PEDRO FALCON CONTRACTORS, INC.

Request for Change Order

Project: Glynn Archer Gym

NOTES:

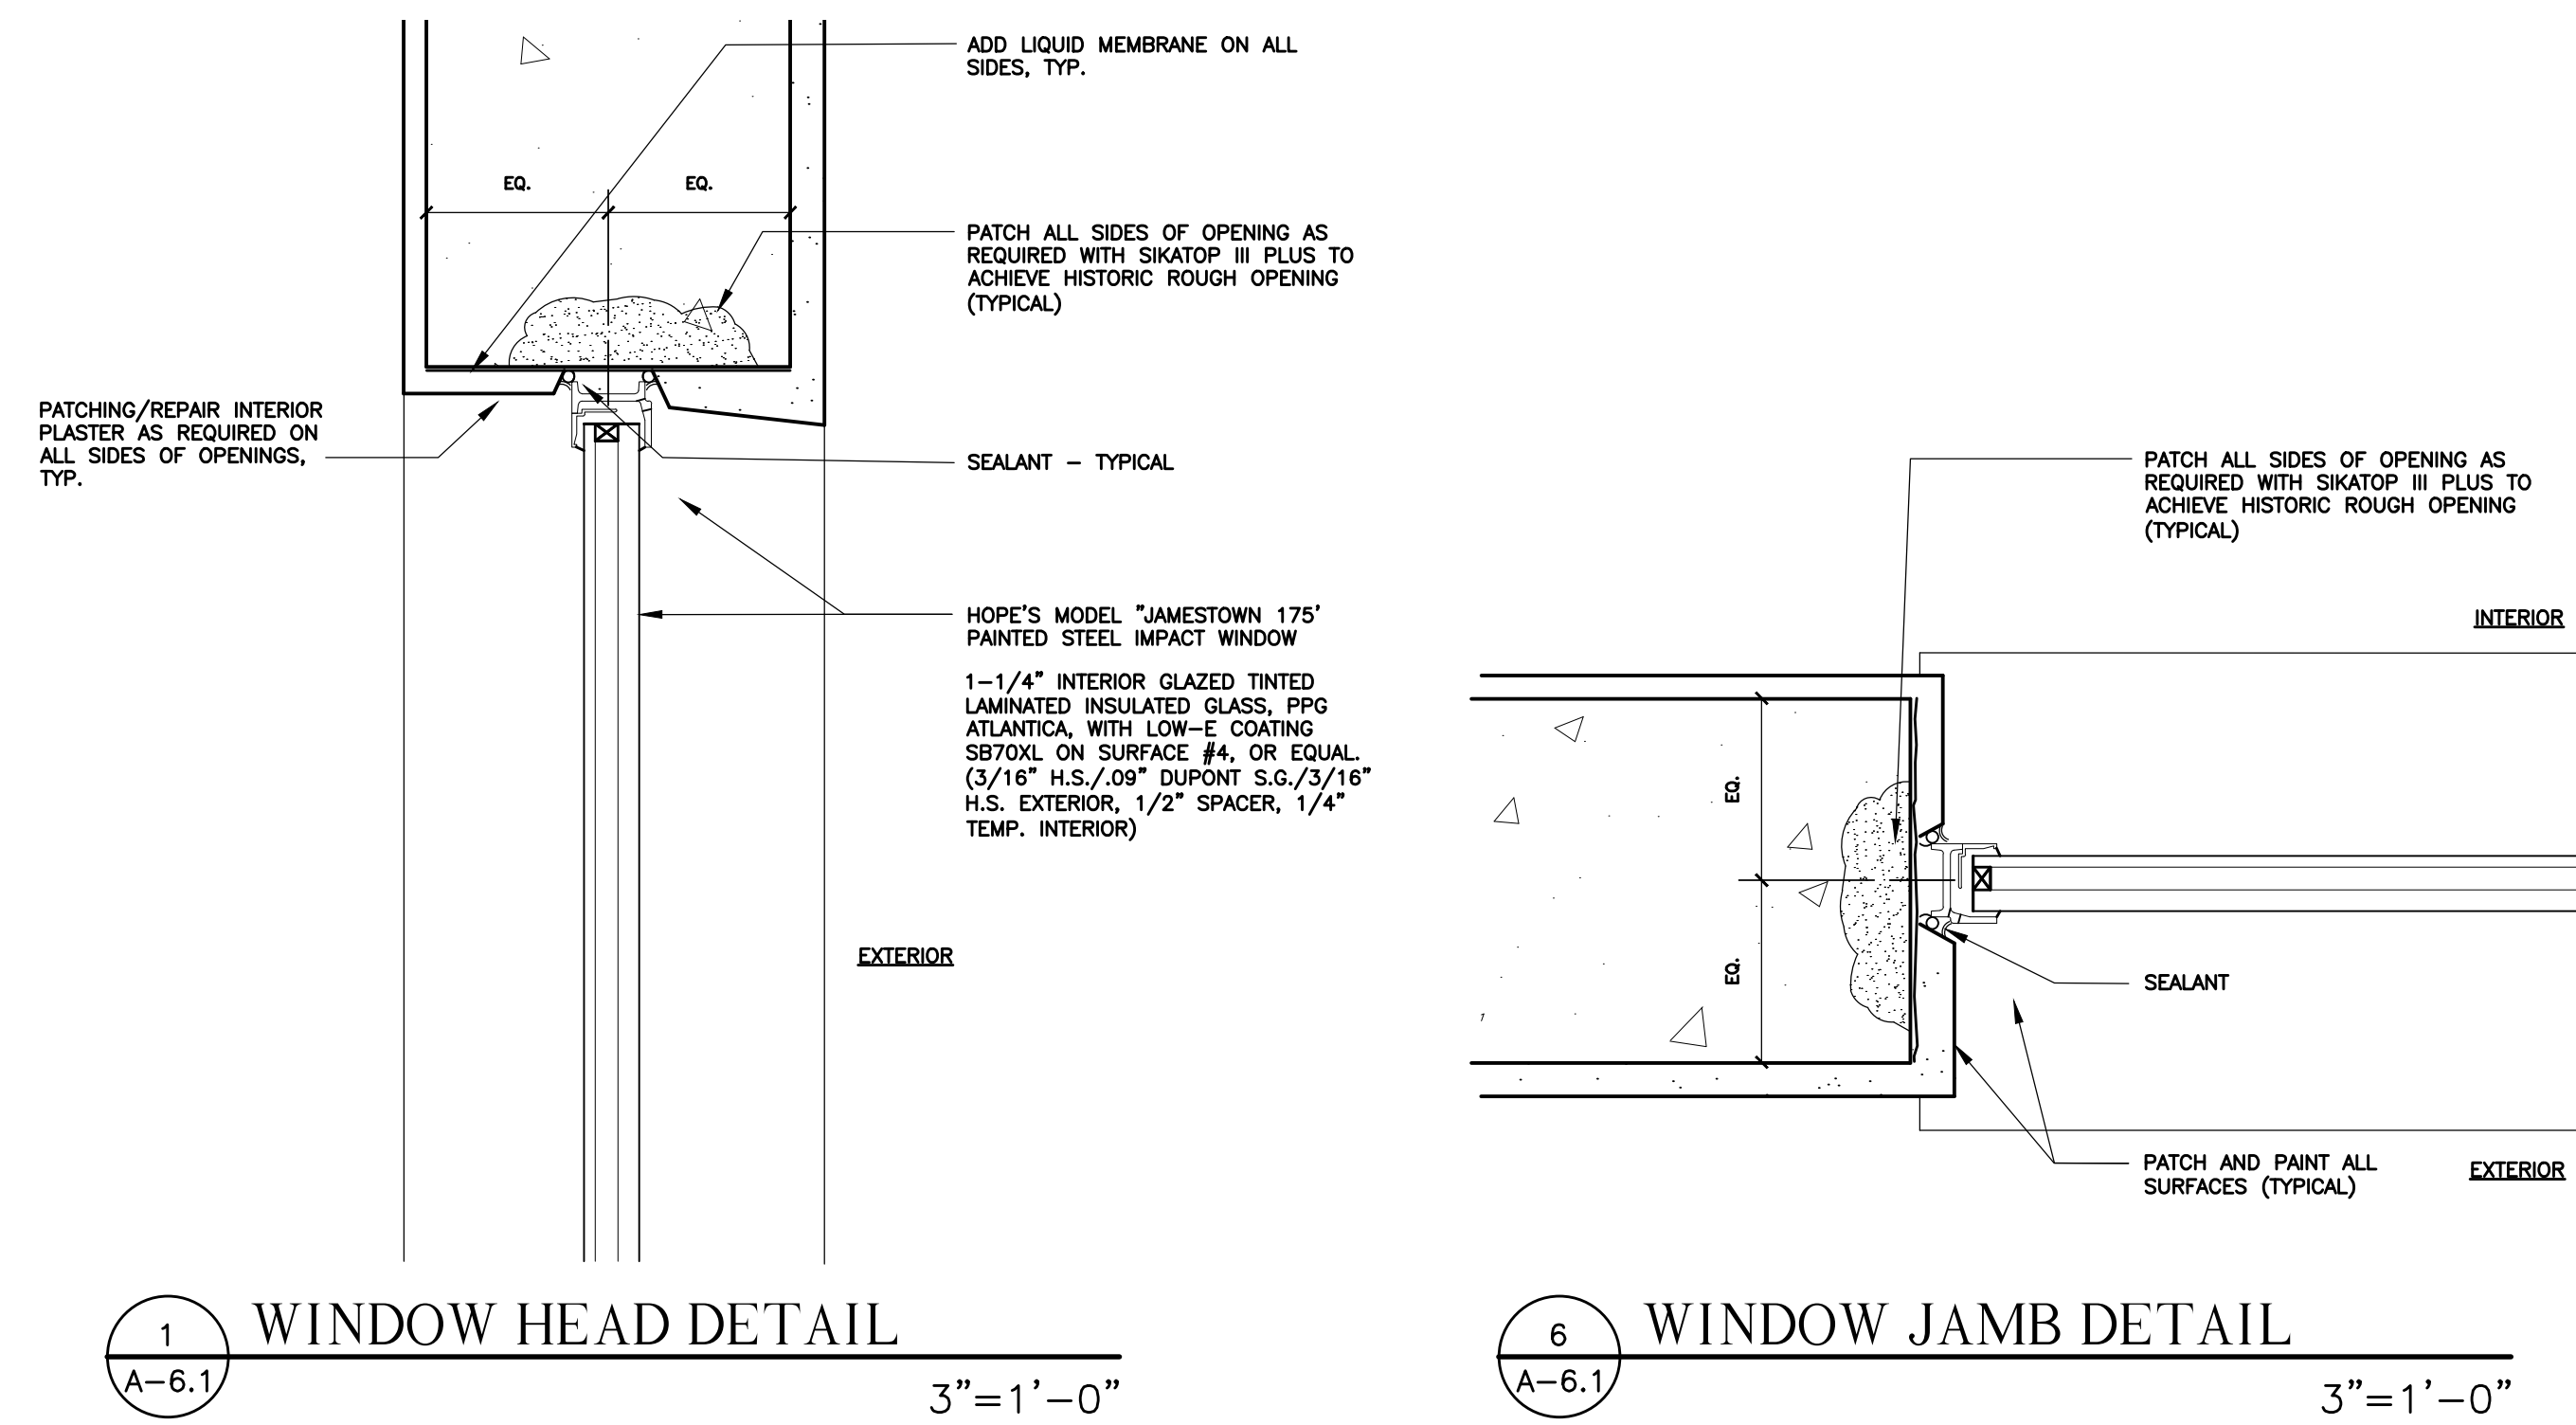
Description: Response to RFI #13 which included a revised drawing for the exterior windows. (see attached revised A-6.1 Drawings enclosed)

Furnish and install a custom simulated divided muntins as shown on the revised architectural drawing sheet A-6.1

To furnish custom simulated divided muntins as requested per architectural drawing sheet A6.1
..... **ADD \$4,651.00**
